HISTORIC AND DESIGN REVIEW COMMISSION

November 15, 2017

HDRC CASE NO: 2017-570
ADDRESS: 402 E EVERGREEN
LEGAL DESCRIPTION: NCB 395 BLK 19 LOT N 120.7 FT OF W 53.9 FT OF 1
ZONING: RM-4 H
CITY COUNCIL DIST.: 1
DISTRICT: Tobin Hill Historic District
APPLICANT: Criswell Humphrey/CCH Projects LLC
OWNER: Criswell Humphrey/CCH Projects LLC
TYPE OF WORK: Exterior modifications, entry modifications, demolition of rear accessory structure
APPLICATION RECEIVED: October 23, 2017
60-DAY REVIEW: December 22, 2017

1 Rear/South Elevation
SCALE: 1/4" = 1'-0"

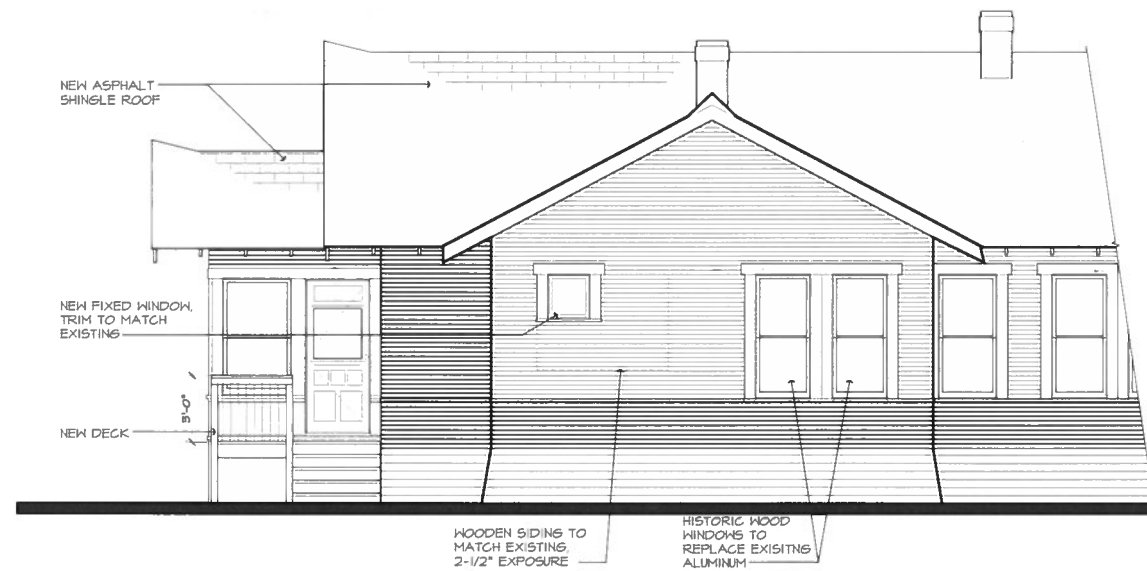
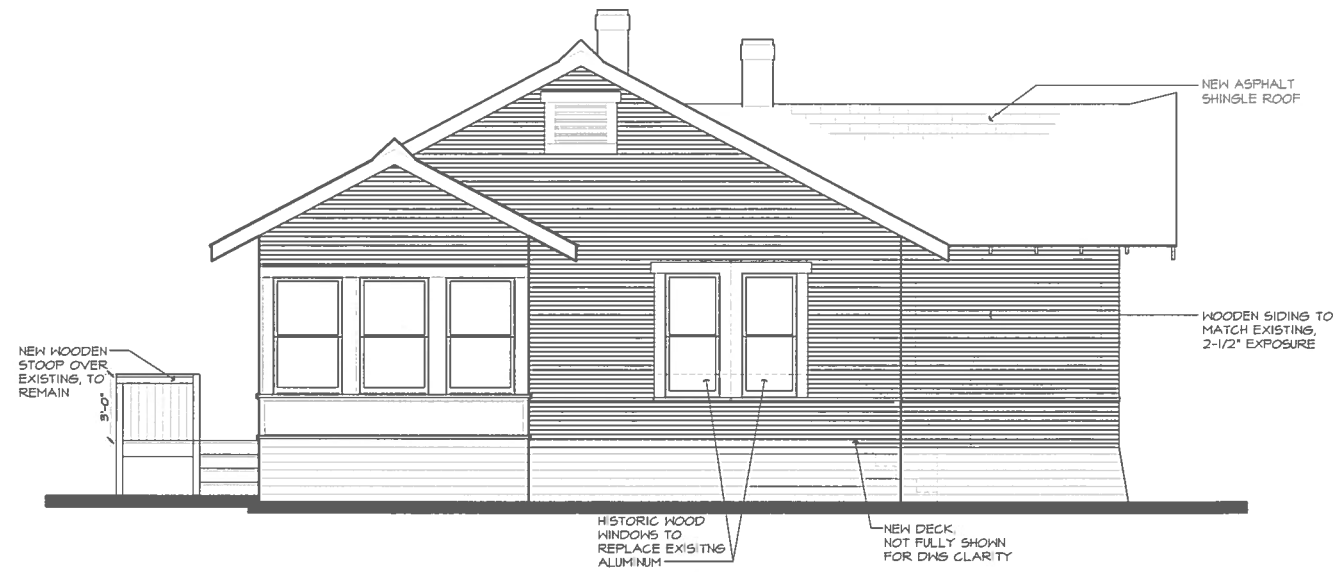
- c. **ALUMINUM WINDOW REMOVAL** – The applicant has proposed to remove three non-original windows on the rear and east façade of the structure. The windows are not appropriate in terms of size, material, configuration, inset, and sill detail. Staff finds the proposal appropriate.

- d. **WOOD WINDOW RELOCATION** – The applicant has proposed to relocate two existing one over one wood windows on the rear façade of the structure. The windows will be installed in the general location of the non-original aluminum windows to be removed. Considering the proposal holistically, staff finds the proposal appropriate.

- f. **NEW REAR DOOR** – The applicant has proposed to relocate an existing door. Based on the submitted elevations, the door will not be visible from the public right-of-way. Staff finds the proposal consistent with the Guidelines.

Items 2 through 5, staff recommends approval of the non-original window removal, window relocation, and new window and door installation based on findings c through f with the following stipulations:

- i. That the applicant submits final measured drawings to staff for approval.
- ii. That the applicant submits final window specifications to staff. The window must be wood. Meeting rails must be

no taller than 1.25” and stiles no wider than 2.25”. There should be a minimum of two inches in depth between the front face of the window trim and the front face of the top window sash. This must be accomplished by recessing the window sufficiently within the opening or with the installation of additional window trim to add thickness. Window trim must feature traditional dimensions and architecturally appropriate sill detail. Window track components must be painted to match the window trim or concealed by a wood window screen set within the opening.

4 Wood Wn. Dtl.
SCALE: 3\"/>

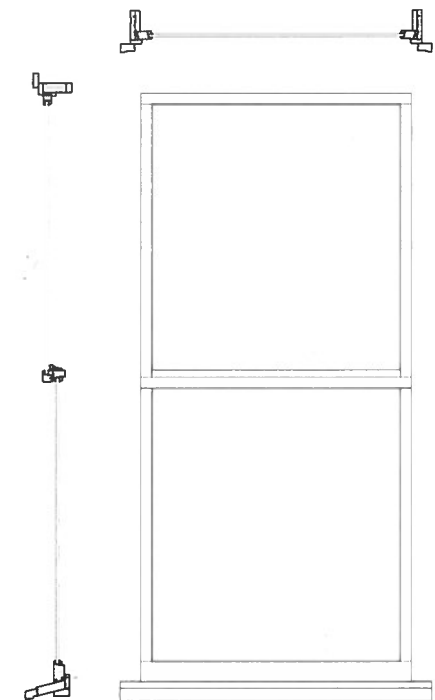
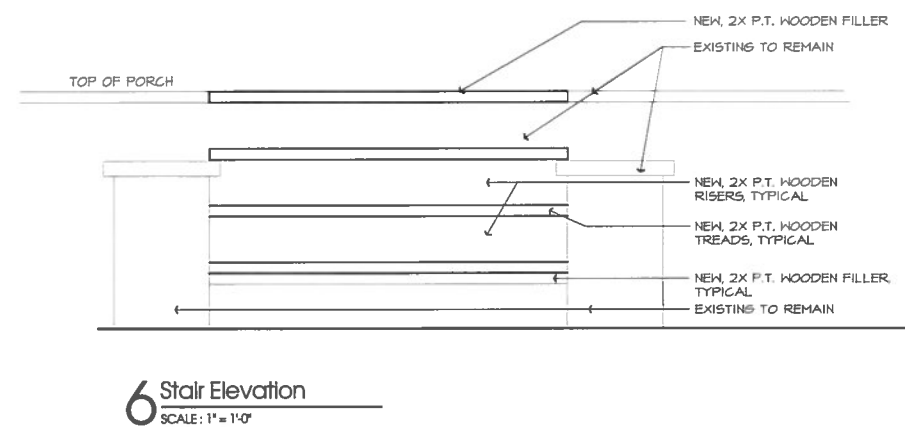
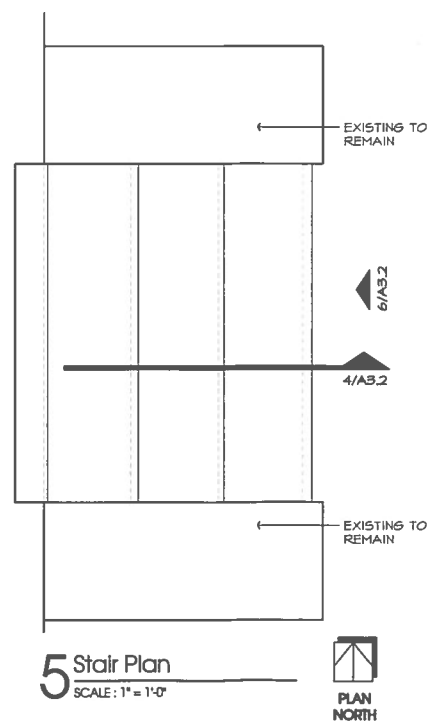
- e. **NEW WINDOW** – The applicant has proposed to install a new fixed wood window on the east façade of the structure, which will be in the location of a new bathroom. The window will be installed in the general location of a non-original aluminum window to be removed. Considering the proposal holistically, staff finds the proposal appropriate with the stipulations listed in the recommendation.

A-3.2
Stair Details

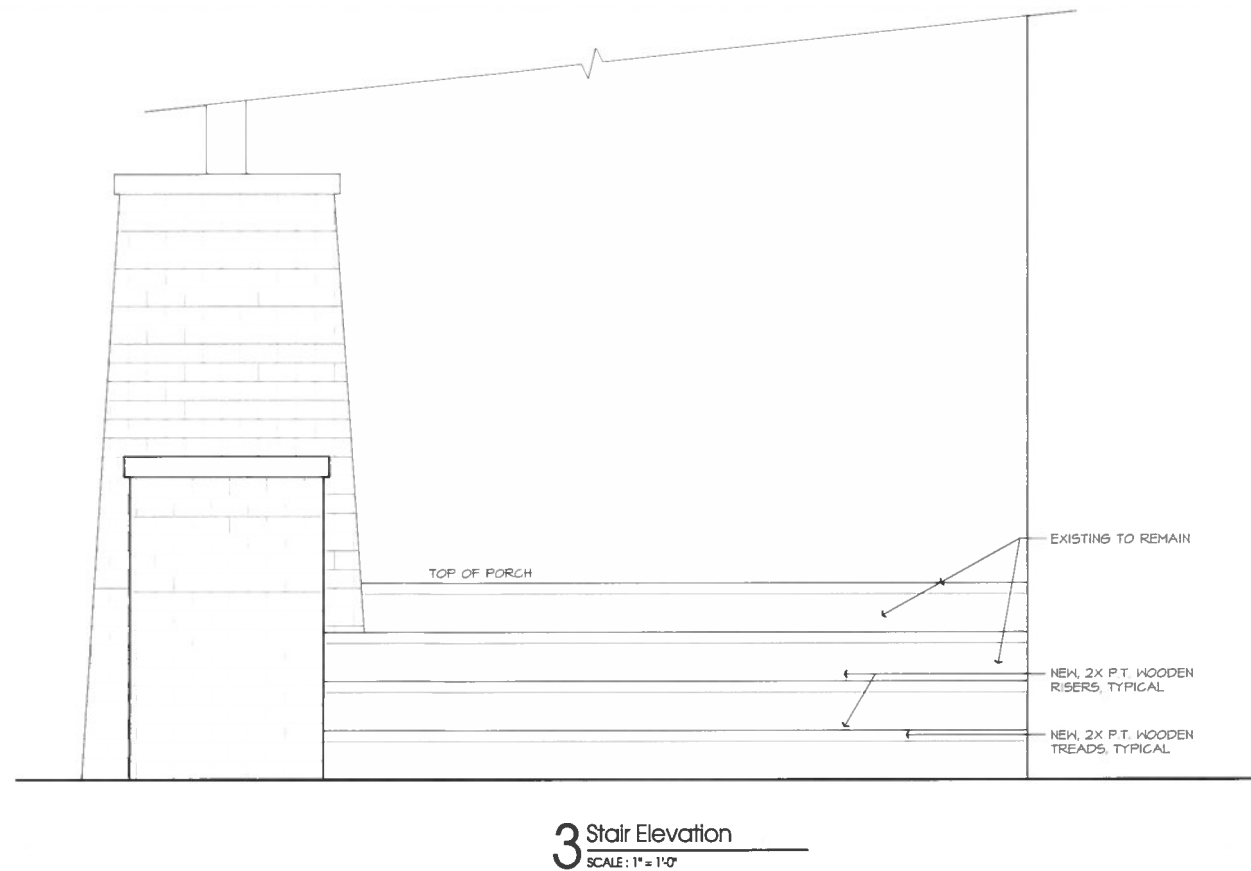
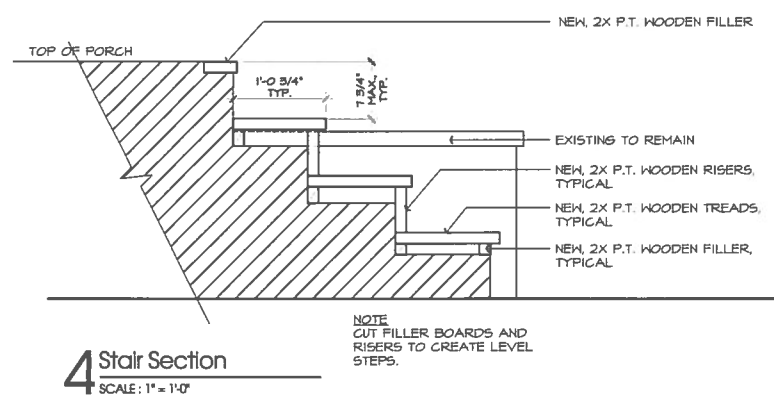
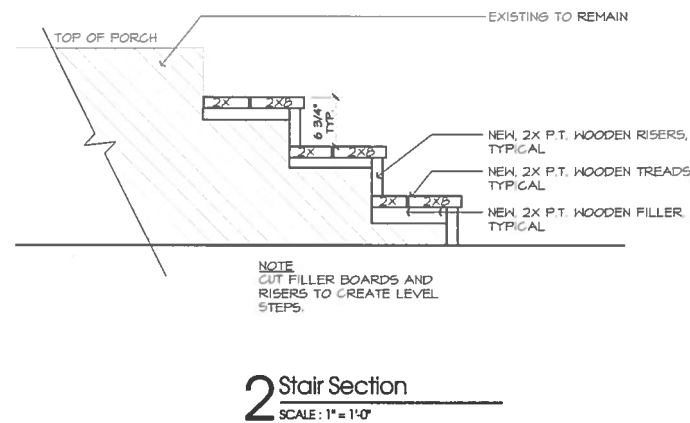
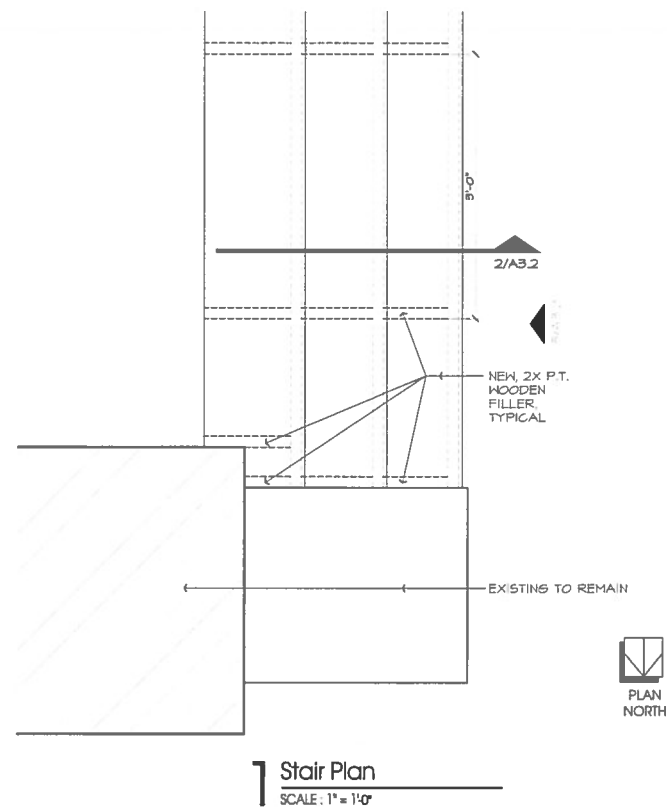
- g. **STAIR MODIFICATIONS** – The applicant has proposed to install new wooden decking over existing concrete stairs at the front porch and a side entry facing Paschal Street. The existing stairs are constructed of concrete with brick and stone surrounds and are in a state of disrepair. The stair element has separated from the primary structure on the Paschal side. According to the Historic Design Guidelines, original concrete porch floors and stairs should be preserved. Original porch concrete elements should not be covered with carpet, tile, or other materials unless they were used historically. Staff does not find the proposal consistent with the Guidelines.

Item 6, Staff does not recommend approval of the wood stair decking based on finding g. Staff recommends that the existing concrete steps be stabilized and repaired.
